Subject: Urgent Attention of the Planning Department

Your reference – PLN-23-0085 – 7A William Street & East Street Campbell Town.

Additional Information Required for Planning Application PLN-23-0106

For Planning Authority Notice

27.4.3 Fencing

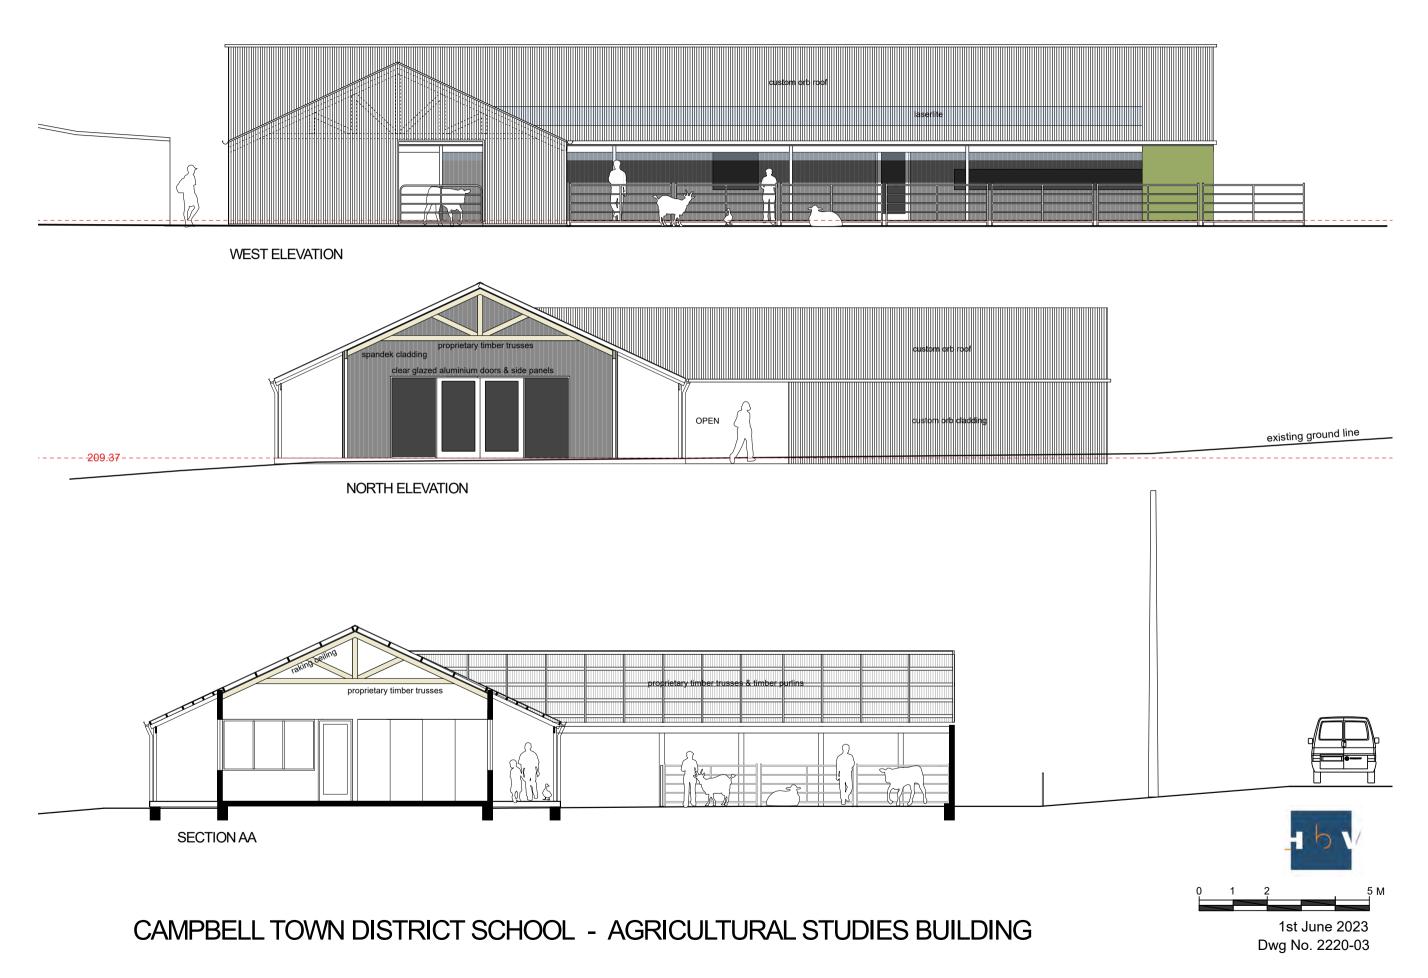
- (b) be compatible with the streetscape, having regard to:
 - (i) its height, design, location and extent;

THE PROPOSED CRICKET NETS FENCING IS APPROXIMATELY 3M HIGH CONSTRUCTED OF CHAINLINK MESH AND DUE TO IT SERVING A DIFFERENT PURPOSE, THAT IS IT ONLY IS BEING PROPOSED FOR SPORTS ACTIVITIES, HAS NO RELATIONSHIP WITH EXISTING FENCES IN THE STREET. THE CRICKET NETS FENCING IS SET BACK 1.2M FROM THE EXISTING STEEL FENCE THAT RUNS ALONG GLENELG STREET (WHICH IS APPROXIMATELY 2.5M FROM THE SITE BOUNDARY) AND HAS A 7M FRONTAGE TO GLENELG STREET. FROM A STREETSCAPE PERSPECTIVE THE PROPOSED FENCE WILL NOT BE VIEWED AS A BOUNDARY FENCE BUT RATHER AN OBJECT WITHIN THE SPORTS PRECINCT OF THE SCHOOL.

Attachment 11.2.16 220833 L O- H Rev P 1

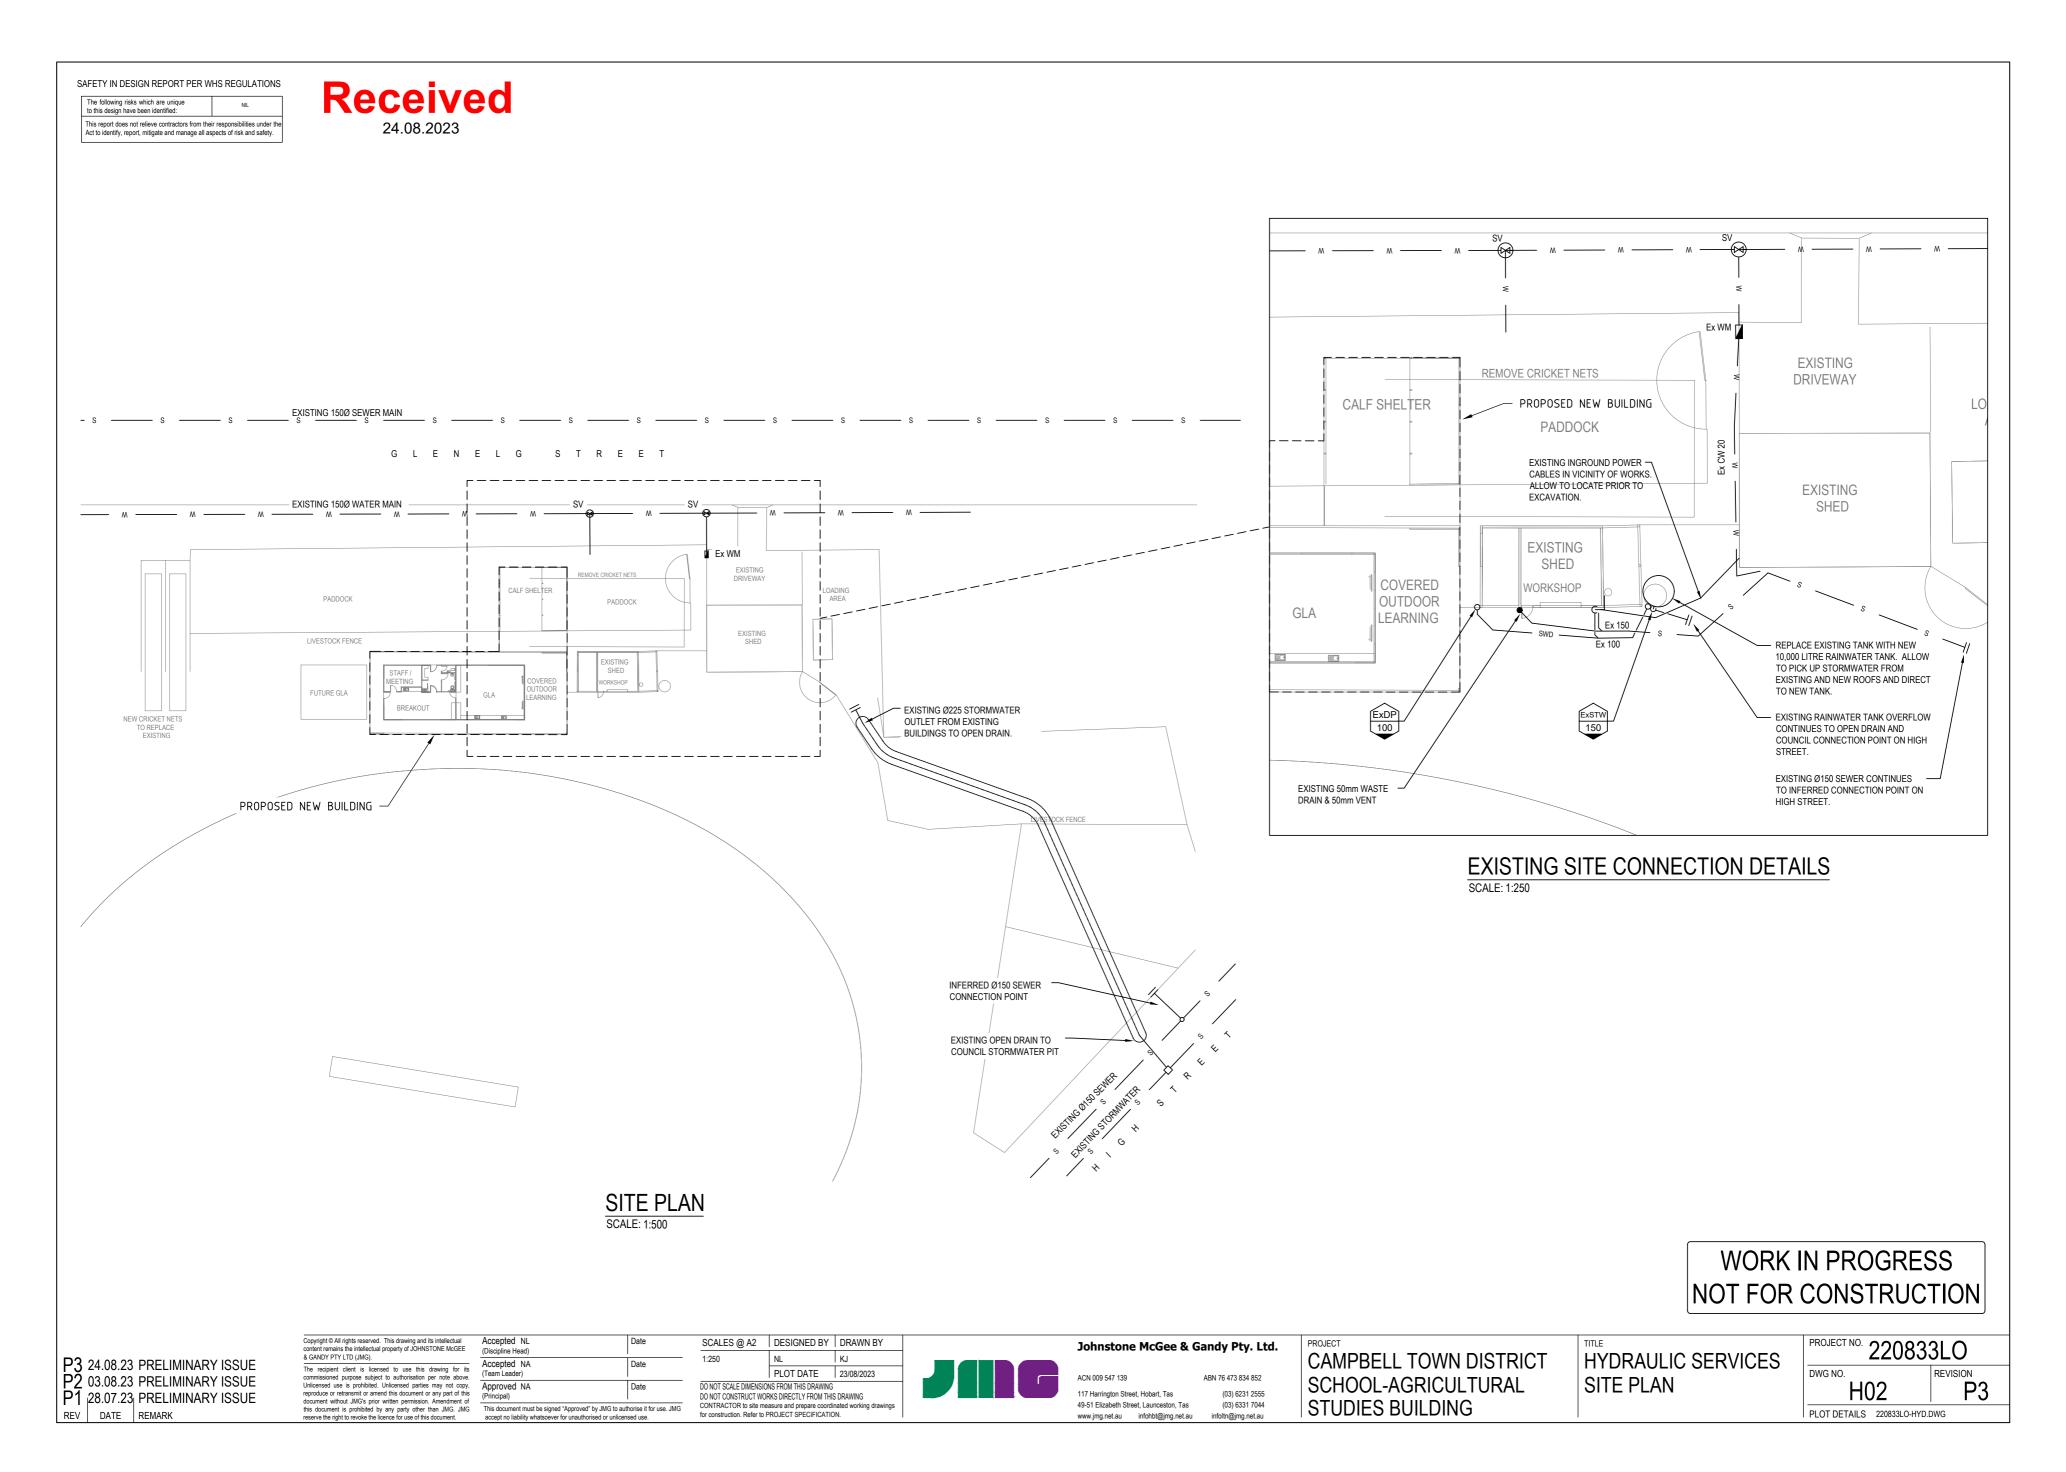
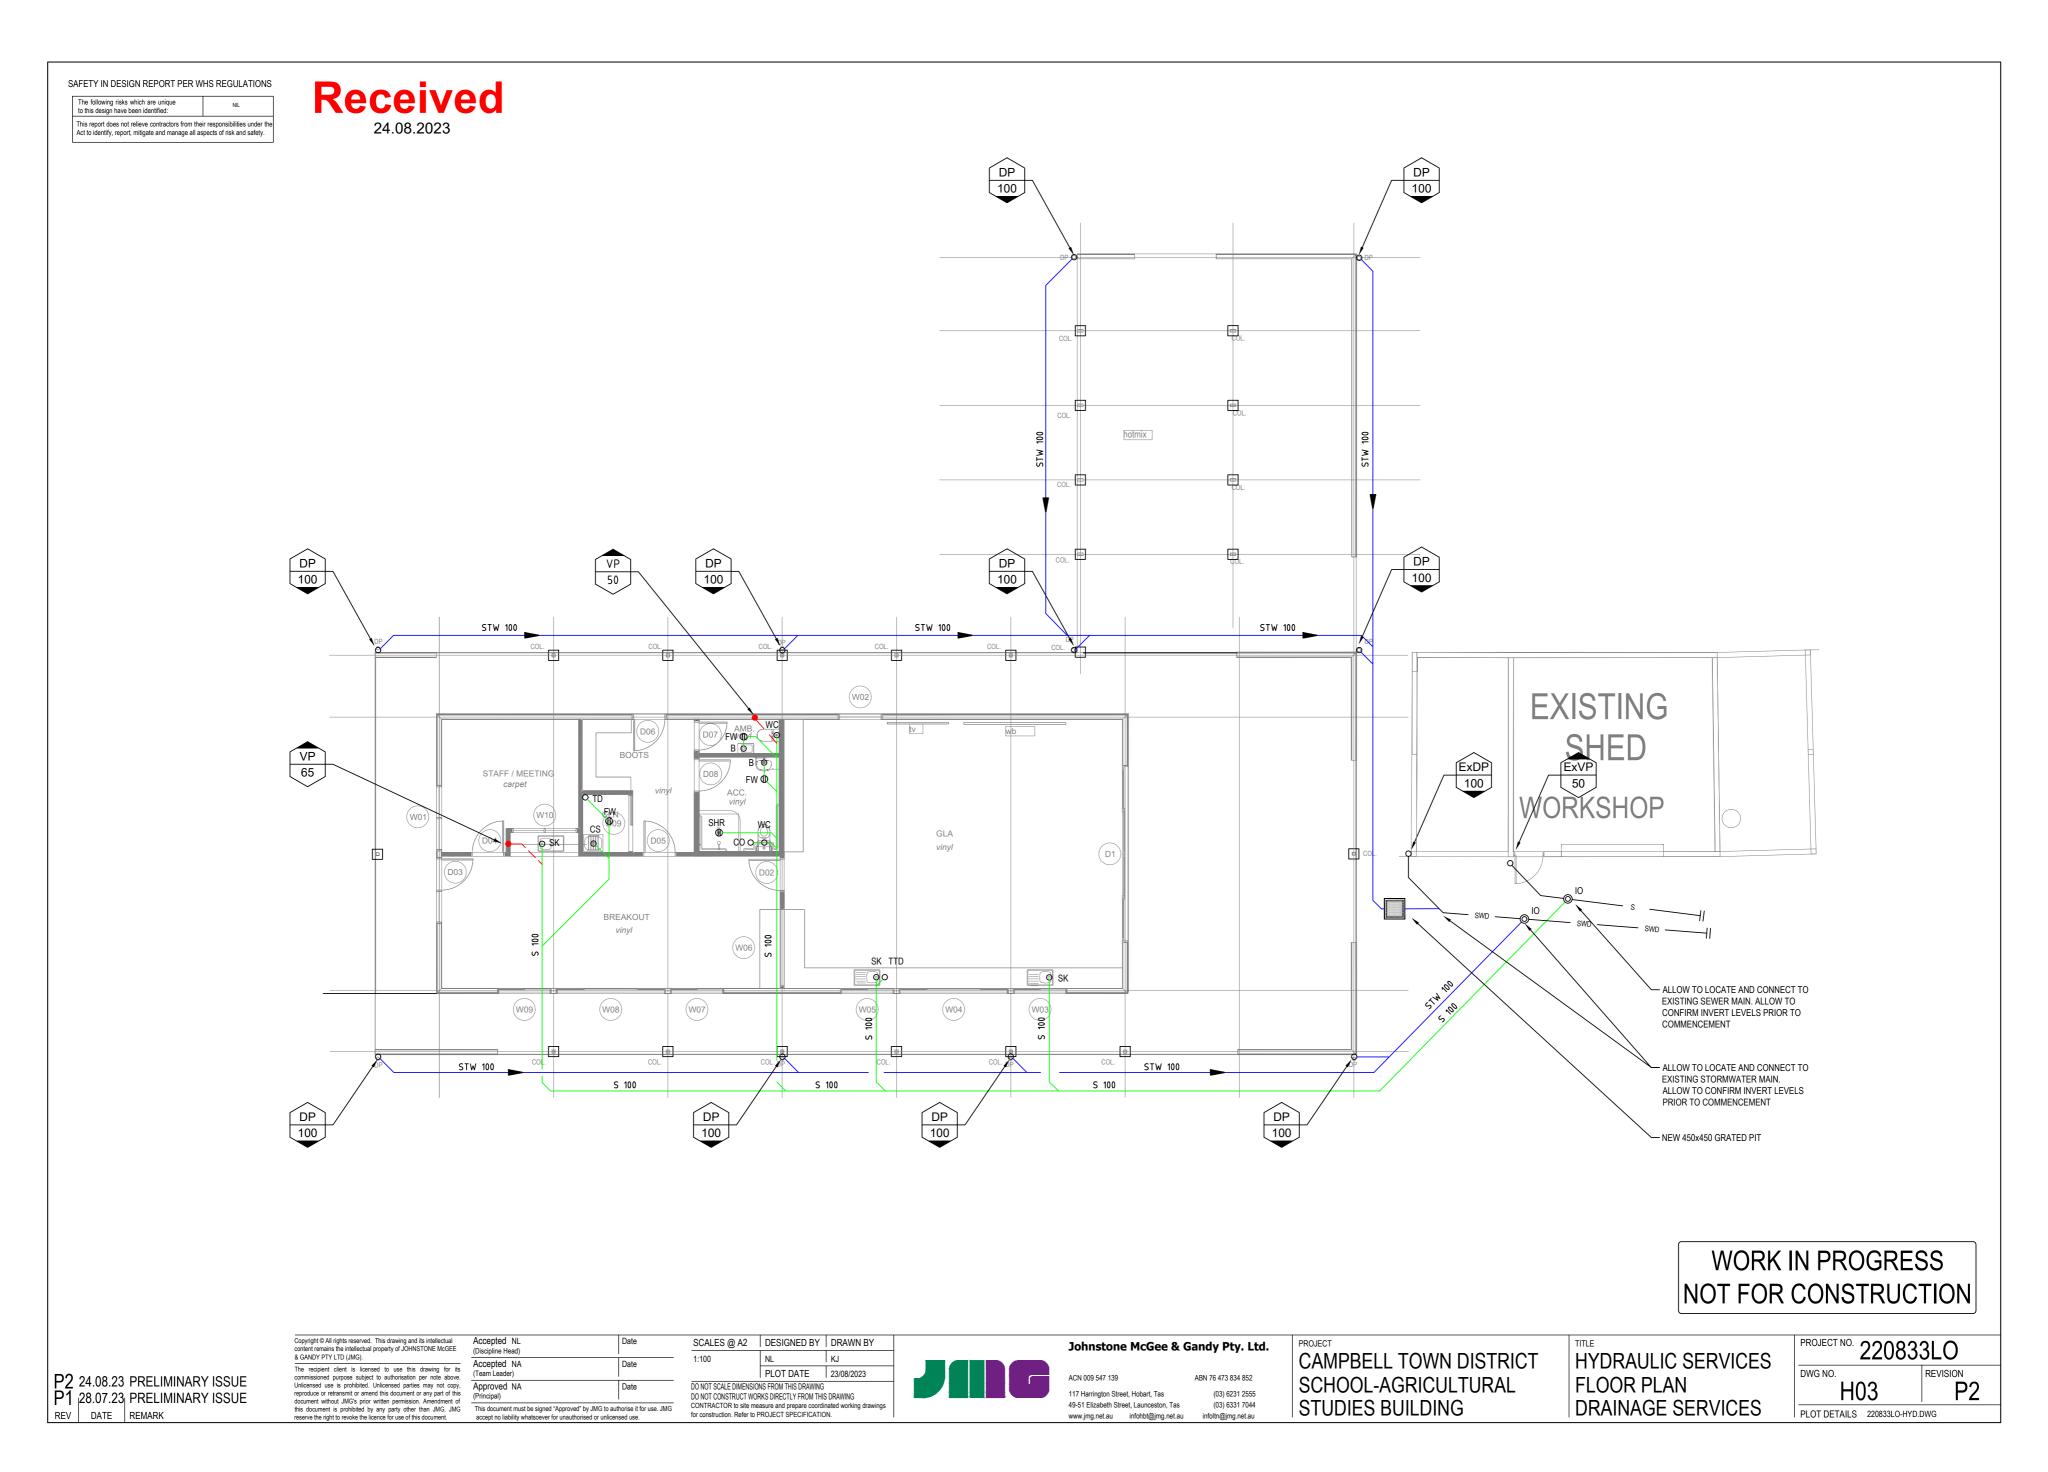
- 3. Please provide a concept servicing plan for water & sewer services for the argricultural building which shows the following:
 - a. The exact location and size of the existing property water & sewer connection(s).
 - b. How it is intended to plumb the proposed building.
 - c. Any water & sewer connection(s) to be made redundant.
